Staff Report

To: Hanahan Planning Commission
Cc: Fred Skipper (Bowen), Ray Wrenn (The Wrenn Group), Larry Sturdivant, Building Official
From: Alexis Kiser, Planner/Economic Development Director
Date: September 22, 2021
Re: Site Plan Approval Midtowne at Bowen, Foster Creek Village, LLC

Staff Report

To: The Hanahan Planning Commission
Cc: Fred Skipper (Bowen), Kevin Coffey (Lowcountry Land Development), Larry Sturdivant, Building Official
From: Alexis Kiser, Planner/Economic Development Director
Date: September 30, 2021
Re: Site Plan Approval for Bowen Greenway

MIDTOWNE AT BOWEN
 BOWEN PIER DR
 HANAHAN, SC
SITE PLAN DIAGRAM (rev1 09.29)

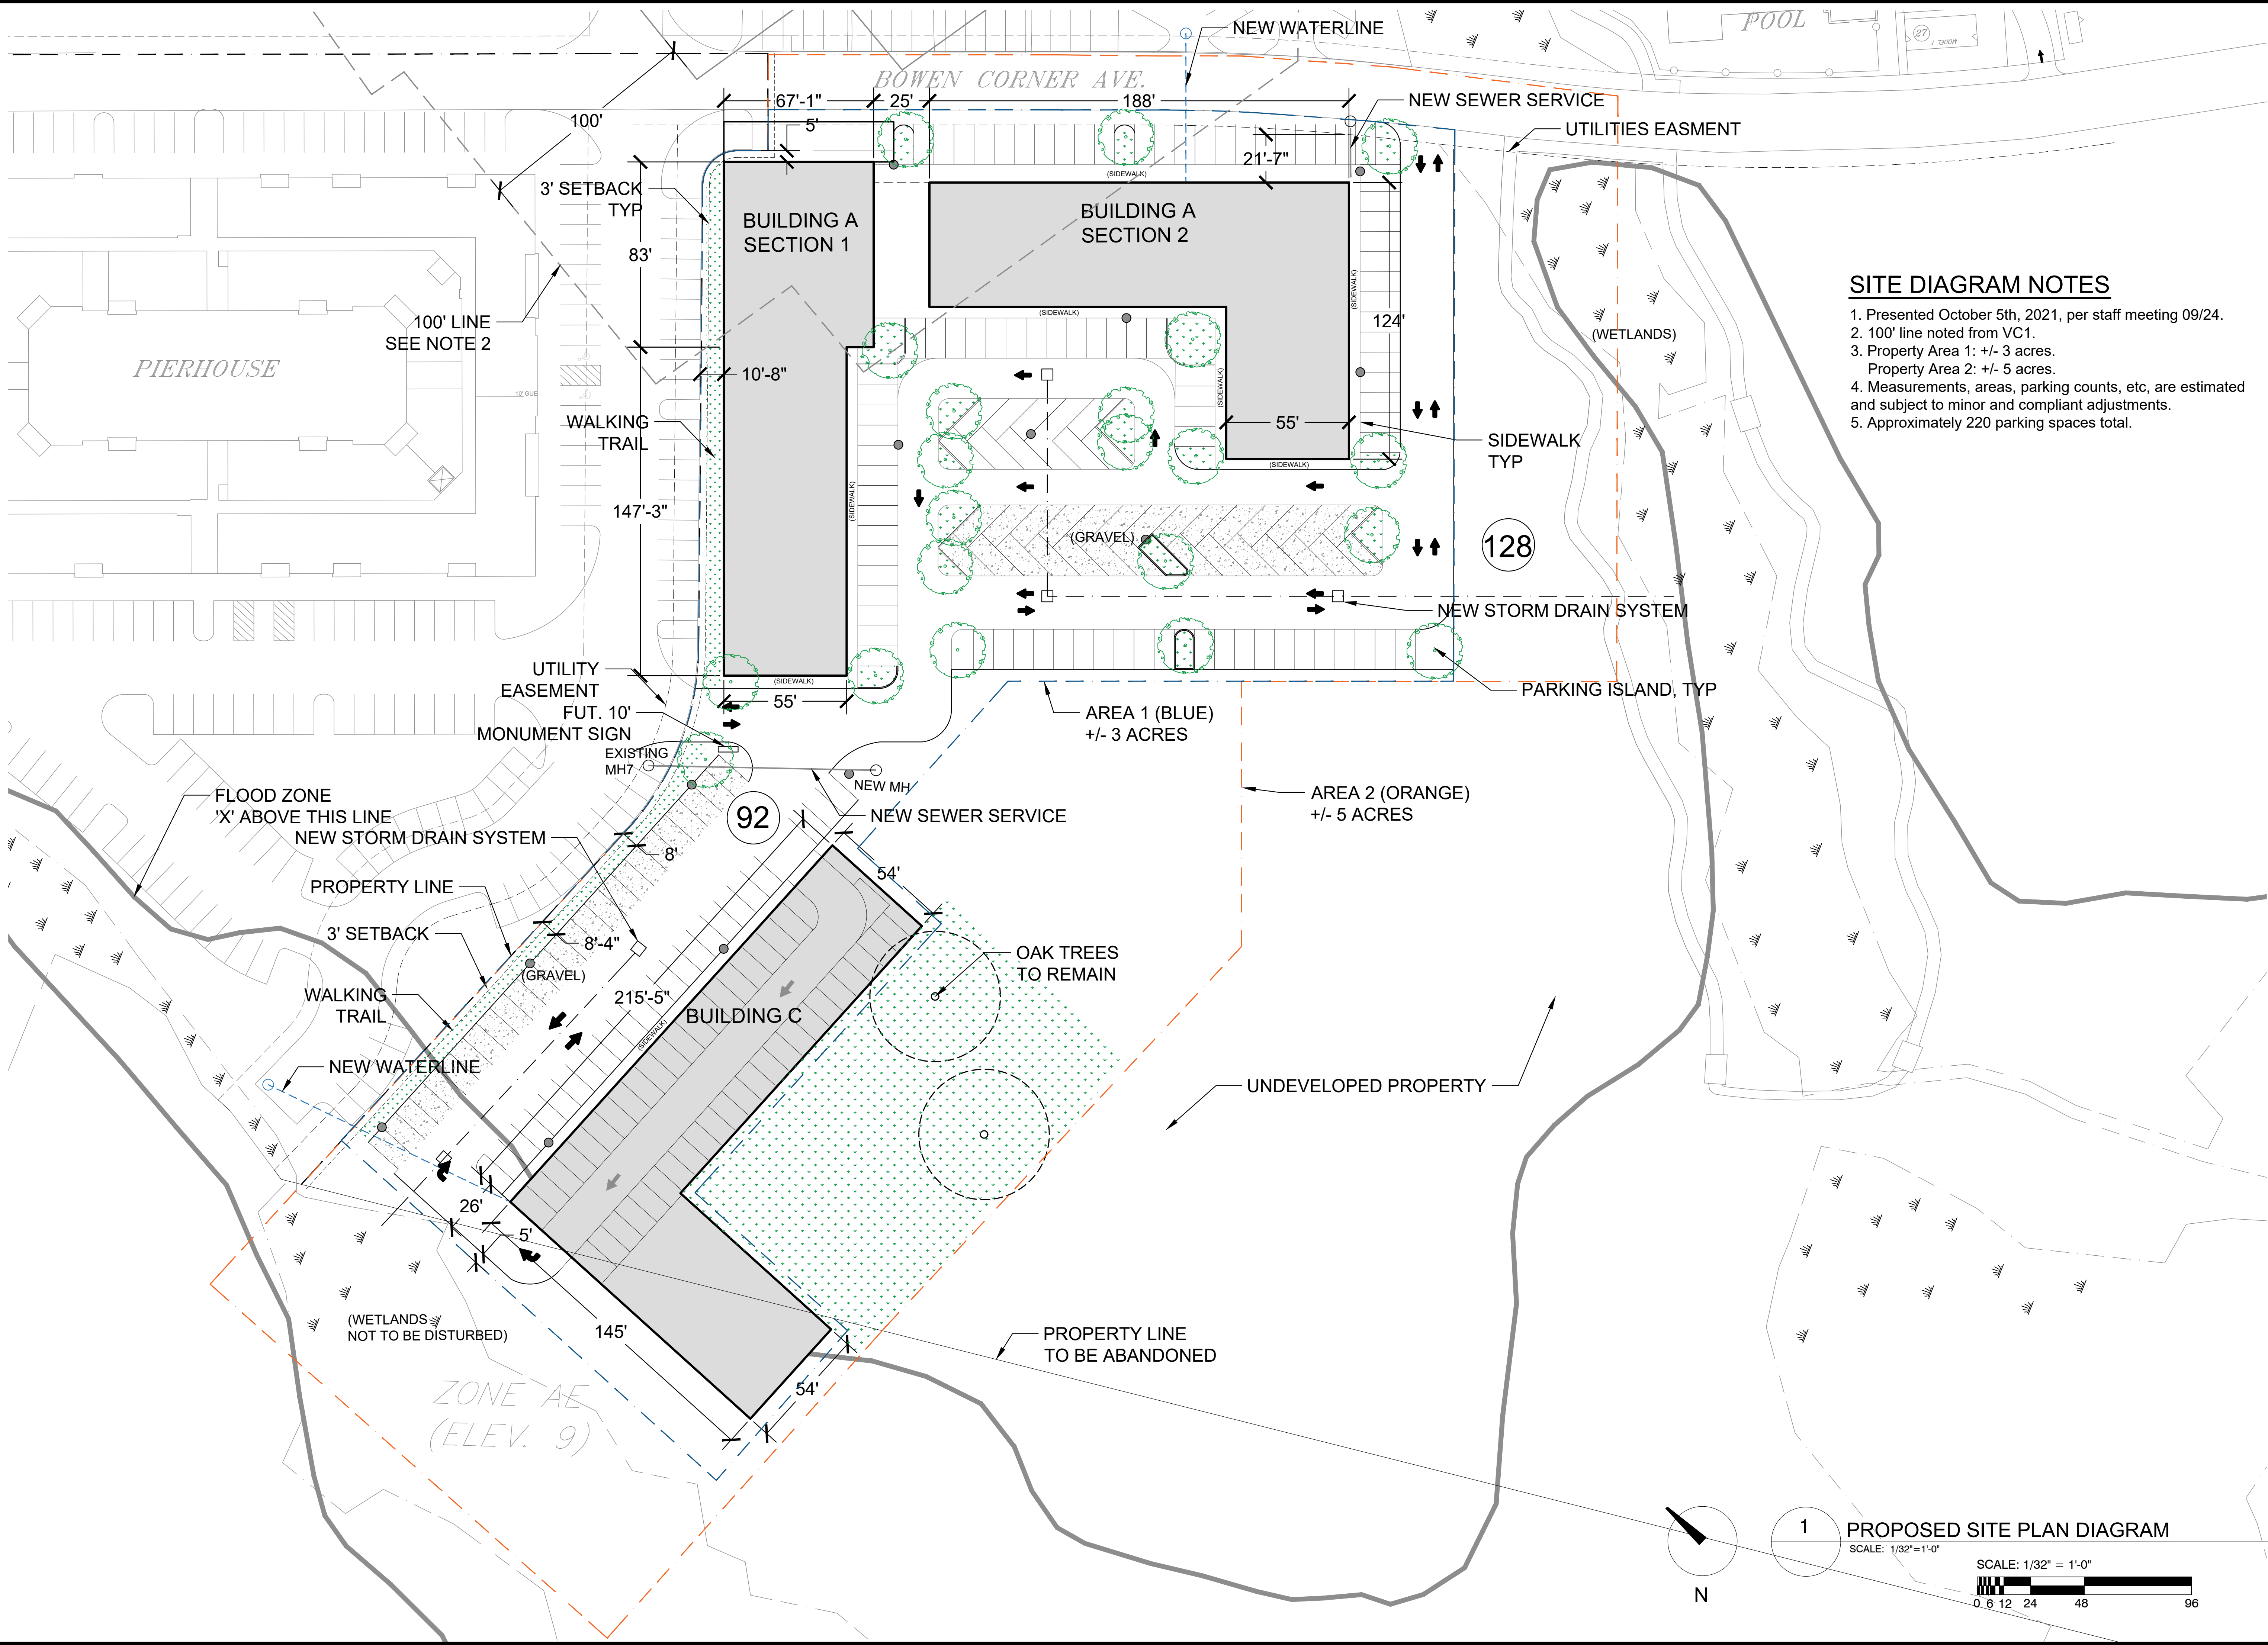
(4) [Page 8]: Contours, showing the topography of the site at a vertical interval of one (1) foot, will need to be shown on the site plan.

(1) [Page 8]: Street rights-of-way, pavement widths, grades, and street names will need to be shown on site plan.

(4) Contour changes to be made by grading will need to be shown in a grading plan.

(7) Areas to be used for purposes other than residential and public, if any, with the purpose, location, and dimensions of each indicated.

5. Design Standards (F)(1) Streetscape (Pg. 6 of PD Document): "One canopy tree with a 2.5" caliper minimum diameter at breast height (DBH) spaced every 40' on center along both sides of all roadways shall be located within the private rights-of-way." These will need to be shown on the site plan or separate landscape plan.

5. Design Standards (G) Site Lighting (Pg. 7 of PD Document): "Site lighting will be required along all streets, and future site amenities". These will need to be shown on the site plan.

A tree protection survey will need to be submitted for the development as this is a wooded, undeveloped piece of property. As included in the PD document and the 1993 Zoning Ordinance, should a tree be within the buildable area it may be removed. However, per the Zoning Ordinance all trees 10" DBH or greater are protected. As such, mitigation will be required should the total amount of trees removed be greater than 25% of trees on the parcel. The required mitigation, per Section 903.2, will be a 1:1 ratio of whatever amount of trees are removed (i.e. 20 trees removed, requires 20 replacement trees be planted), with a caliper per tree being 2".

(3) *Street Lighting:* The approximate location of existing and proposed street lighting will need to be shown on site plans when building permits are submitted.

1. Applicant provides a tree protection survey, highlighting which trees are slated for removal and which trees will be protected.
2. Applicant provides clarity on the location and dimensions of area in Building A that will be used for retail space, to confirm it does not exceed the FCV-FC1 area line.
3. Receipt of recommendation/approval letters from CWS, BCWS and Berkeley County Engineering.

THE GREENWAY AT BOWEN
BOWEN PIER DR
HANAHAN, SC
SITE PLAN DIAGRAM

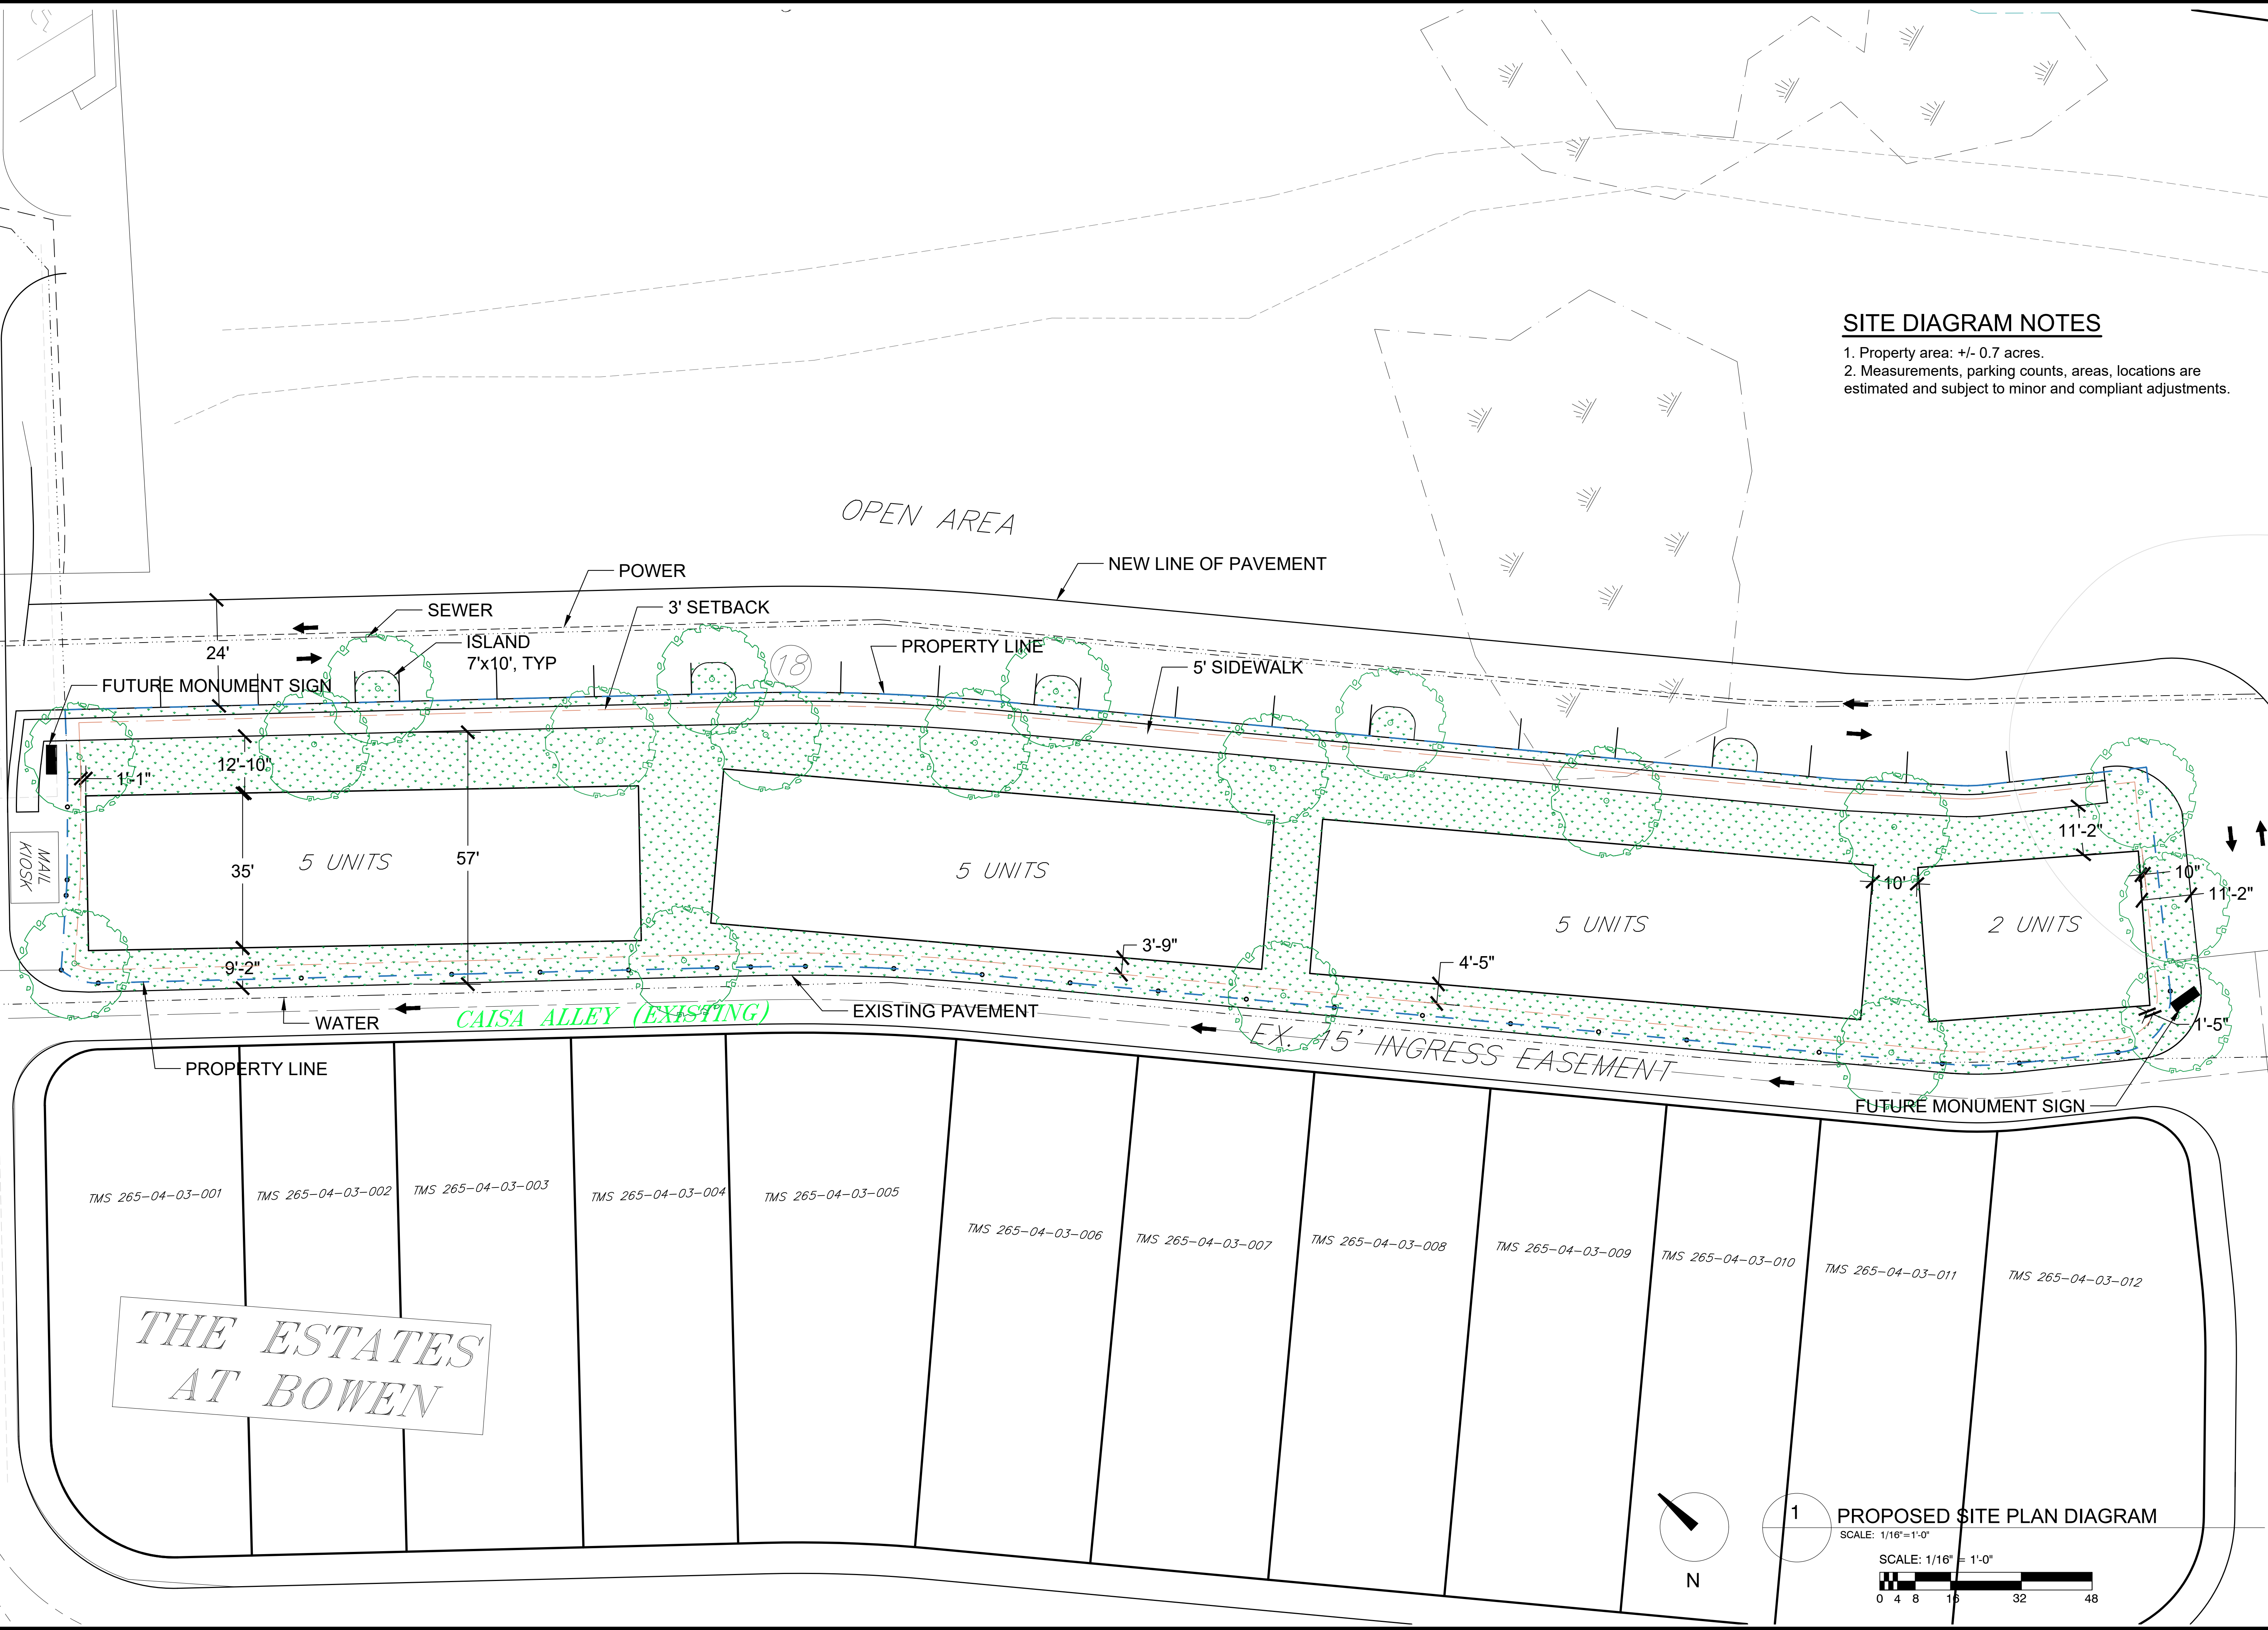
1. The proposed minimum lot size *does not* conform to the PD required minimum for FCV-MF of five (5) acres. The proposed acreage stated on the plat that the "Total Site Area" is 0.7 acres.

Additionally, if looked at through the FCV-TH (Townhome) district on a "by use" basis, the minimum lot size required is 2,500 SF. None of the 17 proposed dwelling units indicate square footage.

(4) [Page 8]: Contours, showing the topography of the site at a vertical interval of one (1) foot, will need to be shown on the site plan.

- (1) [Page 8]: Street rights-of-way, pavement widths, grades, and street names will need to be shown on site plan.
- (4) Contour changes to be made by grading will need to be shown in a grading plan
- (5) Setback measurements will need to be shown on site plan

5. Design Standards (F)(1) Streetscape (Pg. 6 of PD Document): “One canopy tree with a 2.5” caliper minimum diameter at breast height (DBH) spaced every 40’ on center along both sides of all roadways shall be located within the private rights-of-way.” These will need to be shown on the site plan or separate landscape plan.

5. Design Standards (G) Site Lighting (Pg. 7 of PD Document): “Site lighting will be required along all streets, and future site amenities”. These will need to be shown on the site plan.

A tree protection survey will need to be submitted for the development as this is a wooded, undeveloped piece of property. As included in the PD document and the 93’ Zoning Ordinance, should a tree be within the buildable area it may be removed. However, per the Zoning Ordinance all trees 10” DBH or greater are protected. As such, mitigation will be required should the total amount of trees removed be greater than 25% of trees on the parcel. The required mitigation, per Section 903.2, will be a 1:1 ratio of whatever amount of trees are removed (i.e. 20 trees removed, requires 20 replacement trees be planted), with a caliper per tree being 2”.

(4) *Parking.* Per the PD document’s Land Use Table (pg. 14) each condominium will be required to have at least 1.75 parking stall per unit. These numbers would result in a total of 29.75 stalls minimum. Said stalls, with general dimensions, will need to be shown on site plans when building permits are submitted, or else they will be rejected.

(6) The general location and approximate heights of all principal and accessory buildings and **dimensions** of structures.

(9) The general location, character, **size, and height of all signs.**

1. Applicant must correct all proposed lot sizes to be in accordance with the "FCV-MF" district, as stated in the "General Conformance Analysis" section.

2. Complete requested corrections under the "General Conformance Analysis," specifically #1 (minimum lot size)
3. Complete all requested corrections under the "Preliminary Plat Approval Requested Corrections (1984 Subdivision Regulations)" section

4. Complete all requested corrections under the "Preliminary Plat Approval Requested Corrections (FCV PD, Type B Document)" section
5. Complete all requested corrections under the "Site Plan Approval Requested Corrections (1993 Zoning Ordinance)" section

6. Applicant must provide a tree mitigation/protection plan for oaks stated by lot number in the Tree Protection Survey of the report. Completion of this will be contingent upon the receipt of building permit approval.
